1	41228-202-110-003	BLOCK	2.0x1.7x3.5 2024-T351 QQ-A-225/6 ®			
				41228-202-110-001	ASSY					
				-001	PART NO.	NAME	STOCK SIZE	MATERIAL	MATL.SPEC	ZONE
NO. REQ'D PER ASSY					LIST OF MATERIAL					
<div>PROPRIETARY RIGHTS NOTICE</div> <div>THESE DATA ARE PROPRIETARY TO ERA AVIATION, INC. DISCLOSURE, REPRODUCTION, OR USE OF THESE DATA FOR ANY PURPOSE IS FORBIDDEN WITHOUT WRITTEN AUTHORIZATION FROM ERA AVIATION, INC. THE FOREGOING DOES NOT APPLY TO VENDOR PARTS.</div>								<div>CHECK VALVE MOUNTING BLOCK</div> <div>DWG. SIZE C SCALE FULL</div>		
				-001	1	41228-300-003				
		</

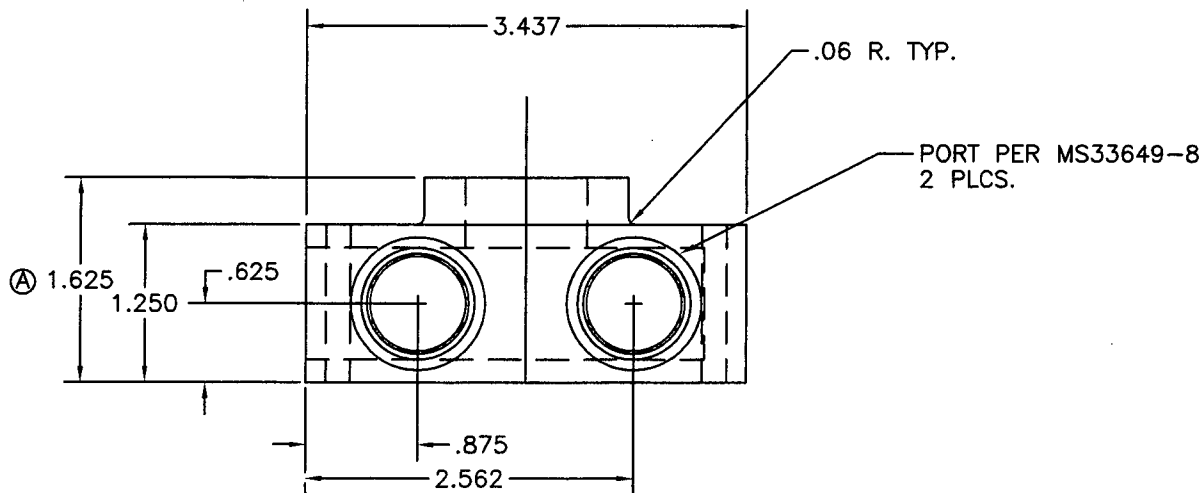
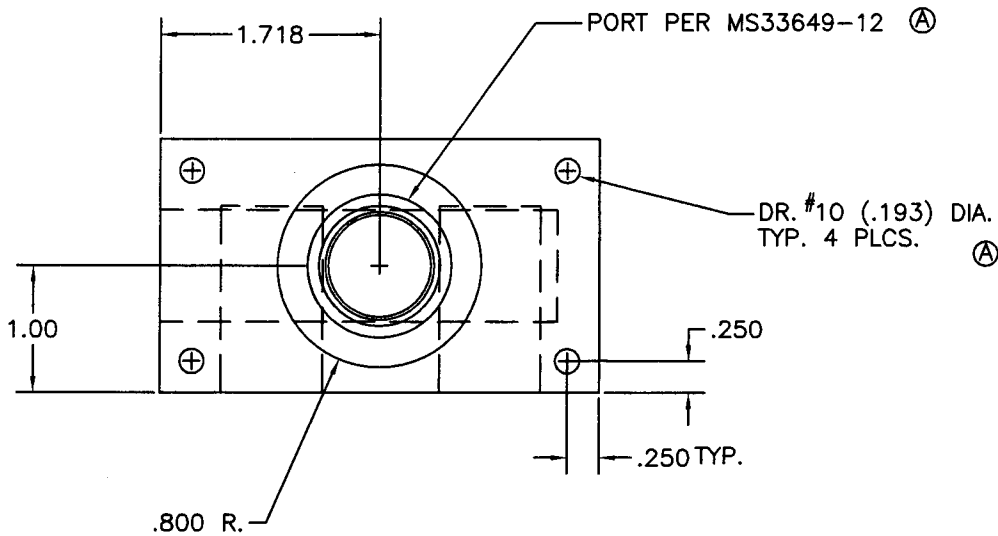
REVISION				APPROVED	DATE
LETTER	DFTSMAN	DATE	DESCRIPTION		
Ⓐ	TAH	9/14/93	ADDED 4 #10 MOUNTING HOLES. RELOCATED HOLE ON TOP OF BLOCK, CHANGED THICKNESS OF BLOCK		
Ⓑ	TAH	9/29/93	CANCELLED NOTE 1 & CHANGED MATERIAL SPEC. REMOVED INSERT FROM L/M		
Ⓒ	TAH	10/29/93	REVISED NOTE 4.

- Ⓐ PROCESSING ANODIZE MIL-A-8625 TYPE II, CLASS 2, DYED RED. Ⓒ
 3. PENETRANT INSP. PER MIL-STD-6866.
 Ⓐ 125/ ALL MACHINE SURFACES.
 Ⓐ CANCELLED Ⓑ
